Point Beach Nuclear Plant

NRC 2009-0030
10 CFR 50.90

License Amendment Request 261
Extended Power Uprate

Attachment 3 identifies the associated changes (marked up pages) to the Technical Specification Bases. These changes are provided for information only. Following approval of the requested Facility Operating Licenses and Technical Specification changes, the Technical Specification Bases will be revised.

Figure B 2.1.1-1 (page 1 of 2)
Illustration of Overtemperature and Overpower Delta-T Protection
For 2000 psia Operation

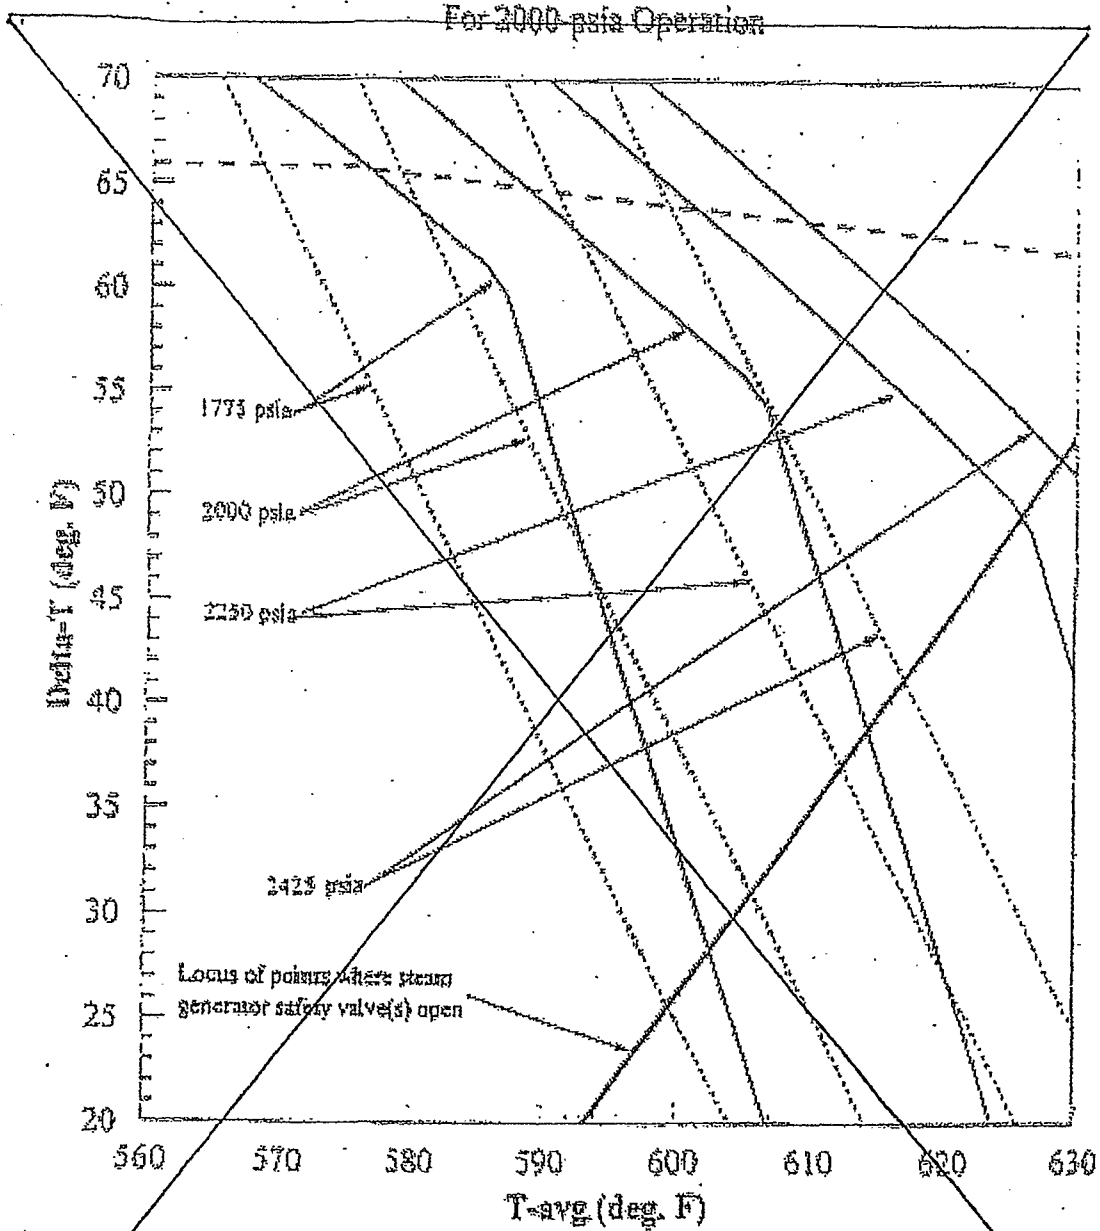
Deleted
(2000 psia Operation No longer
Applicable)

Figure B 2.1.1-1 (page 2 of 2)
Illustration of Overtemperature and Overpower Delta-T Protection
For 2250 psia Operation

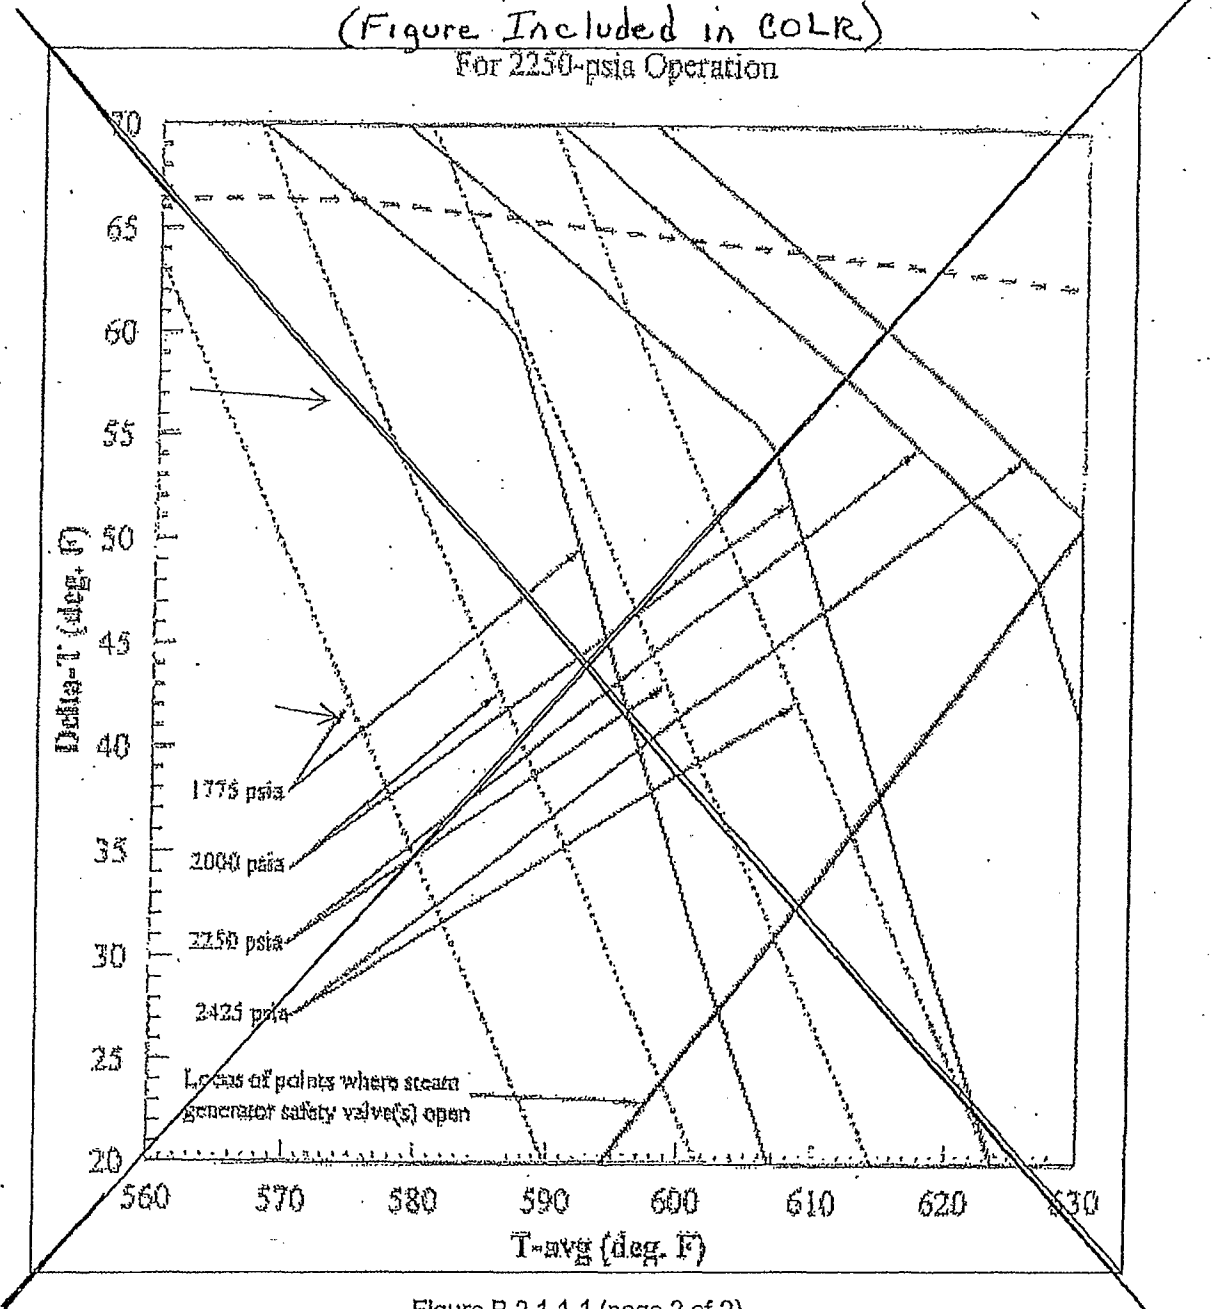
Deleted
(Figure Included in COLR)
For 2250-psia Operation
